Magnolia Public Schools

Regular Board Meeting & MPS Board Retreat

Approval of Construction and Contractor Change Orders for the Magnolia Science Academy-5 (7111 Winnetka) Project

Re: Magnolia Science Academy 5 Project – Increment #2, Del Amo Construction
Prime Contract Change Order 033

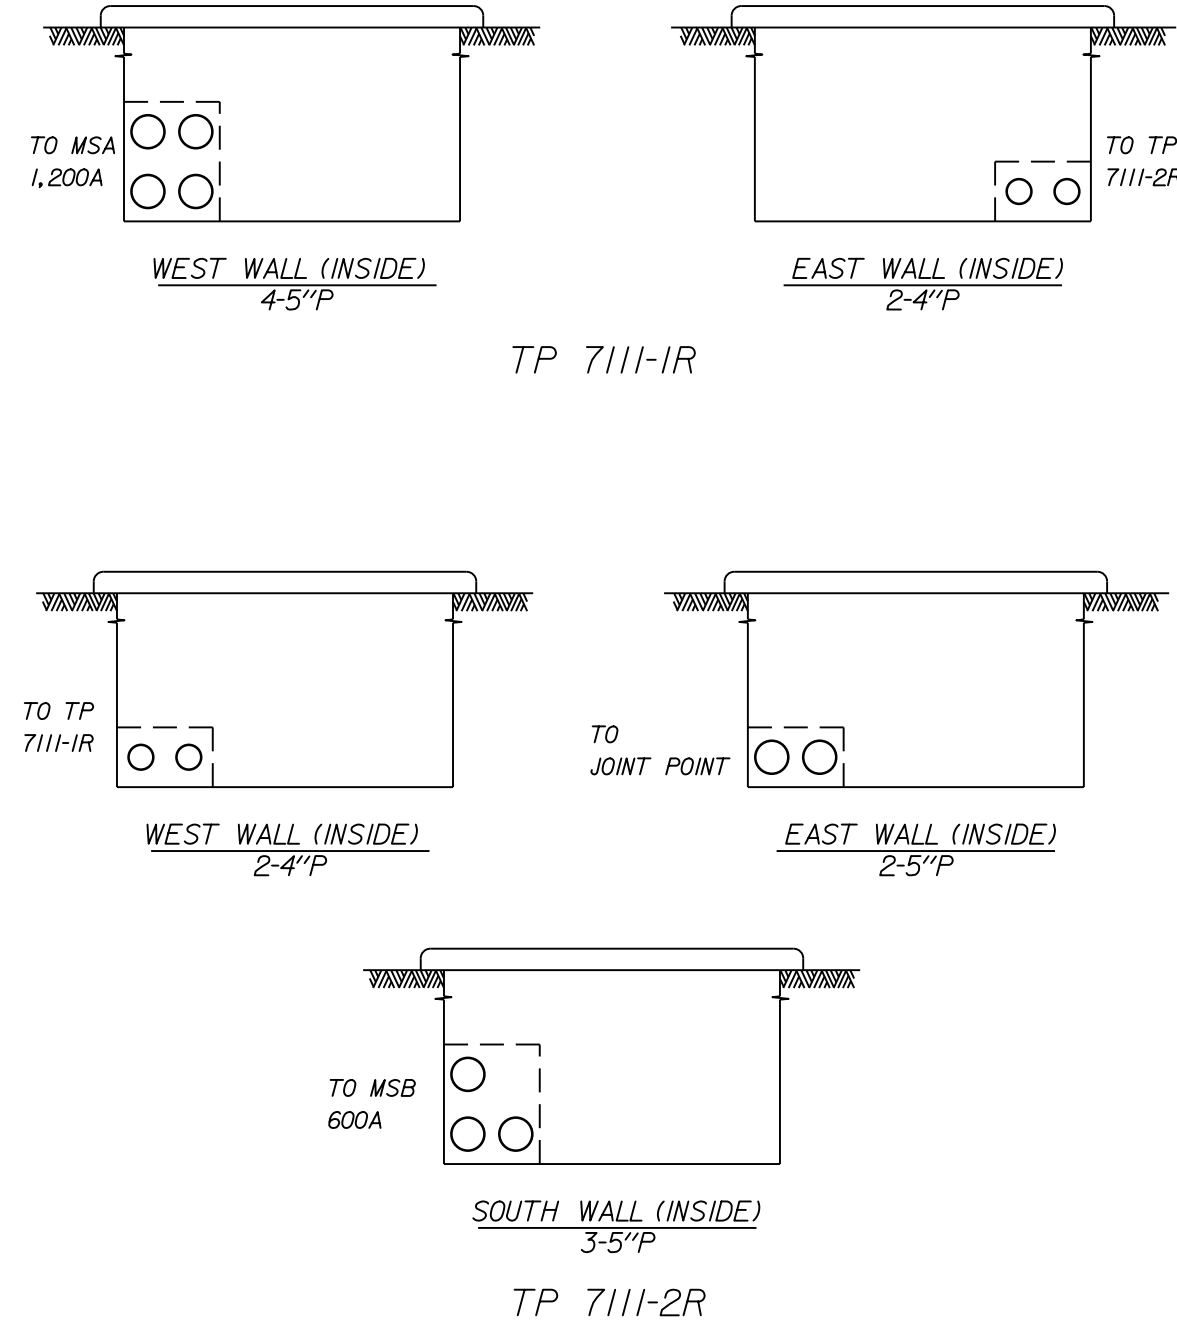
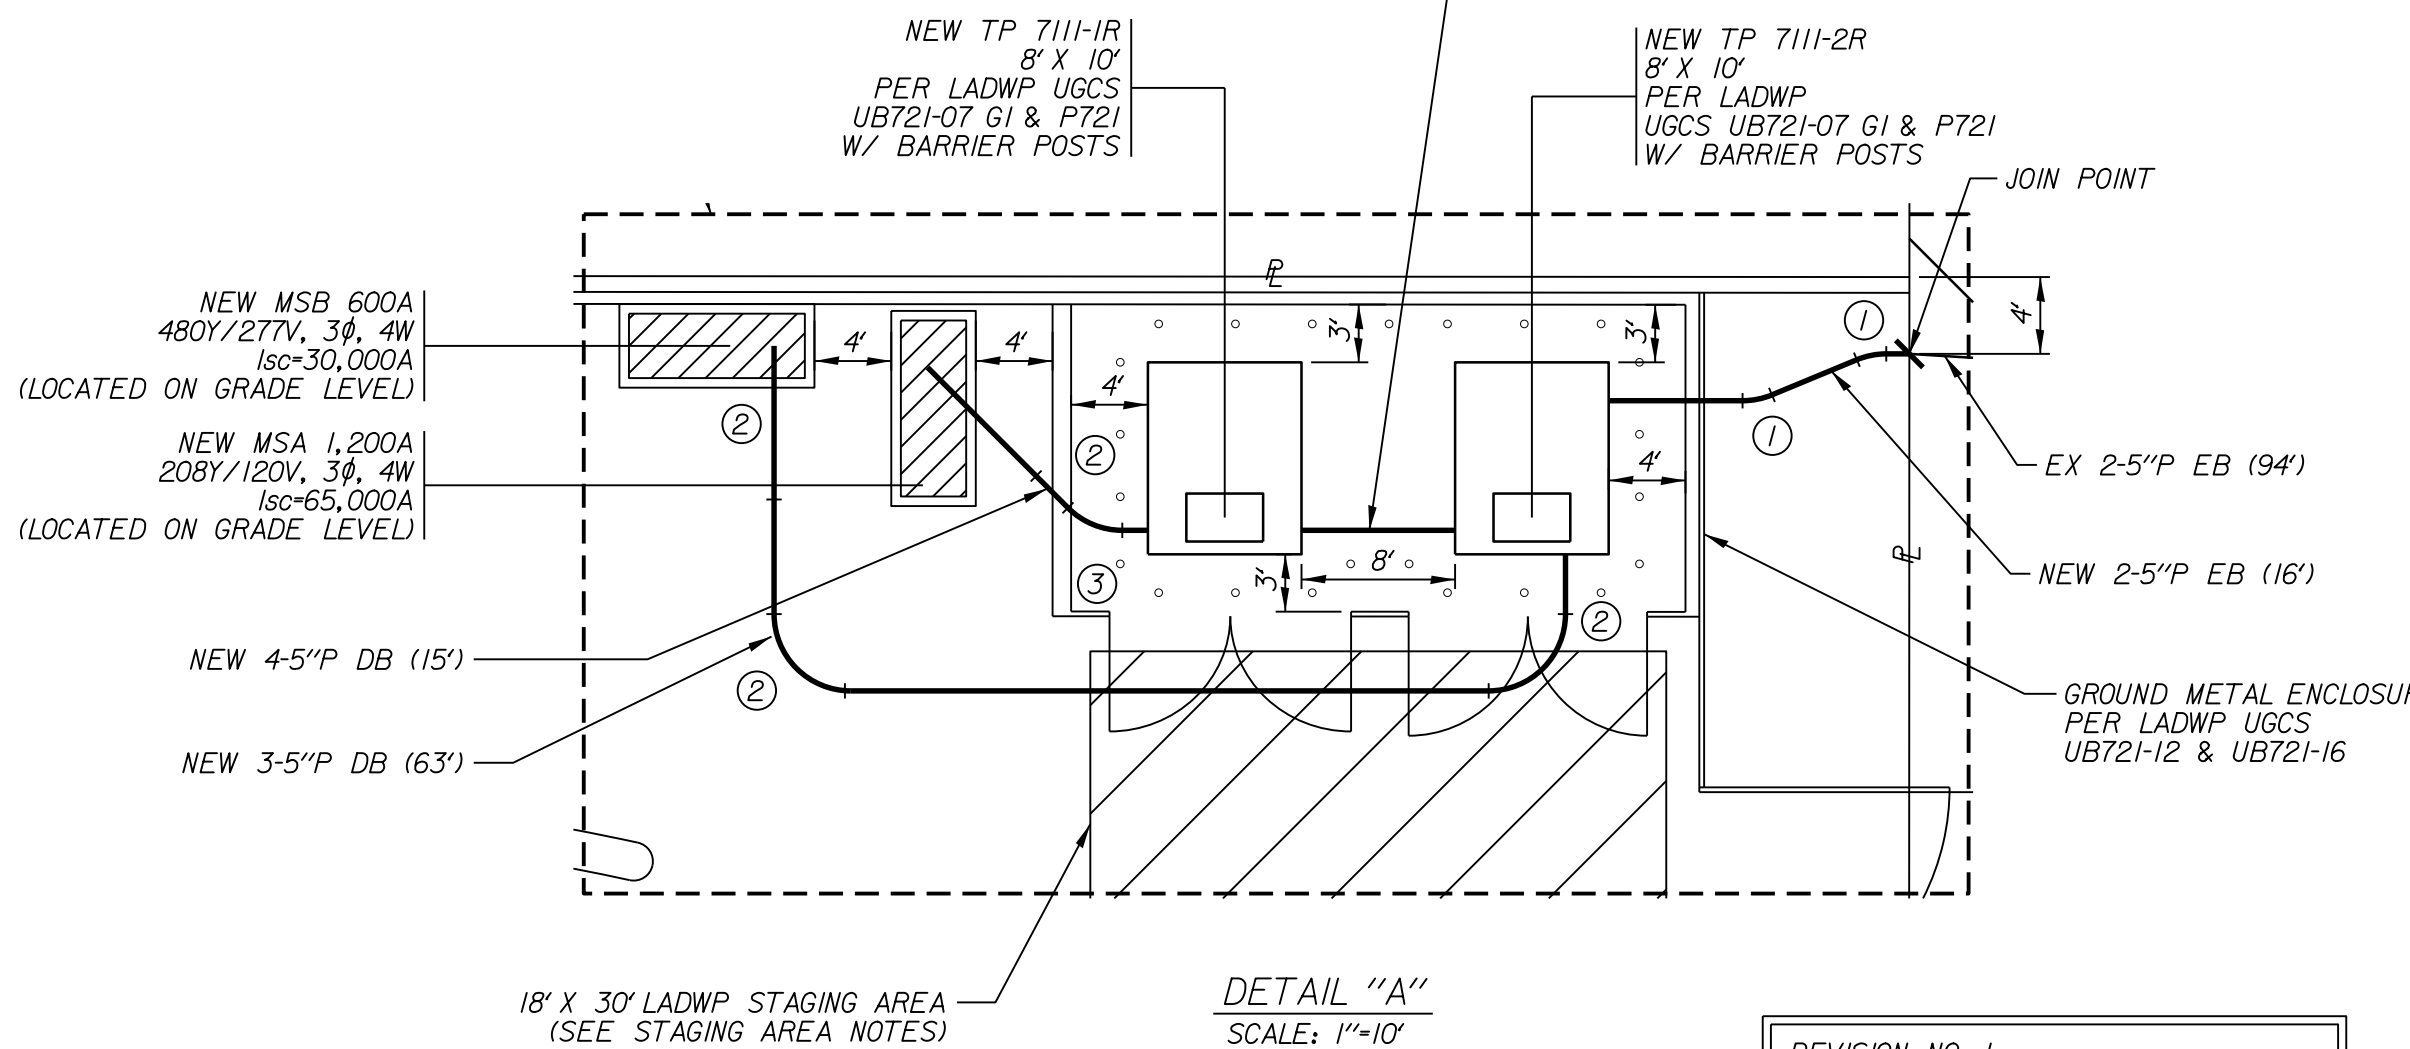
Transformer Bollards: Bollards to be located at LADWP transformer pad were not included in the bid set. DLR did not show the bollards from LADWP "P" Drawings on the bid documents. Del Amo was requested to procure and install these required items.

Furnish F.O.B. (28) Pipe Bollards for Transformer Pads.

COR 16

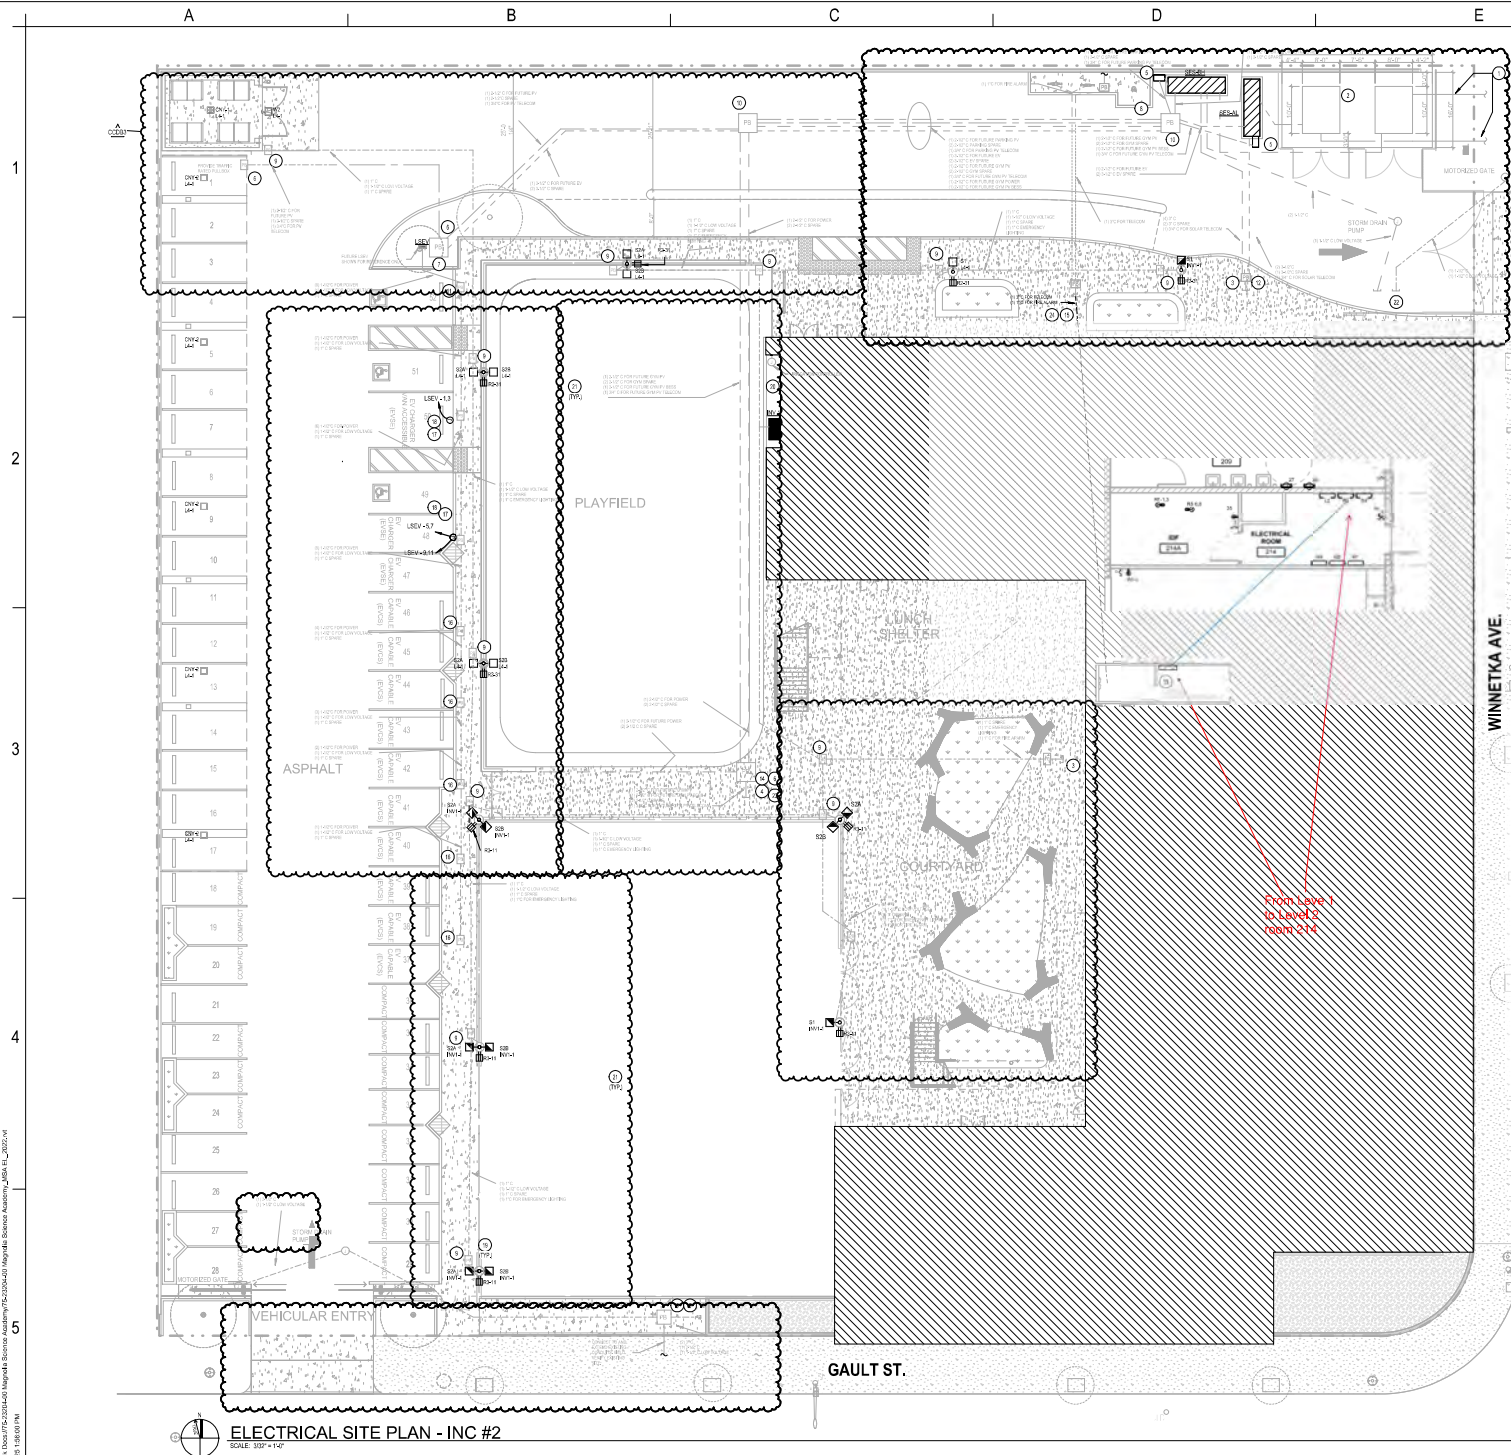
Additional Modular Panel Runs: Per RFI 58 and SCM RFP response, SCM excluded all modular panel runs despite being designated for SCM scope in the bid documents. This created scope gap. As previously mentioned, this is due to coordination error between DLR and SCM. This change order accounts for the final modular panel runs delegated to DAC subcontractor, Safeway. The runs include connections from 1st Floor to 2nd Floor.
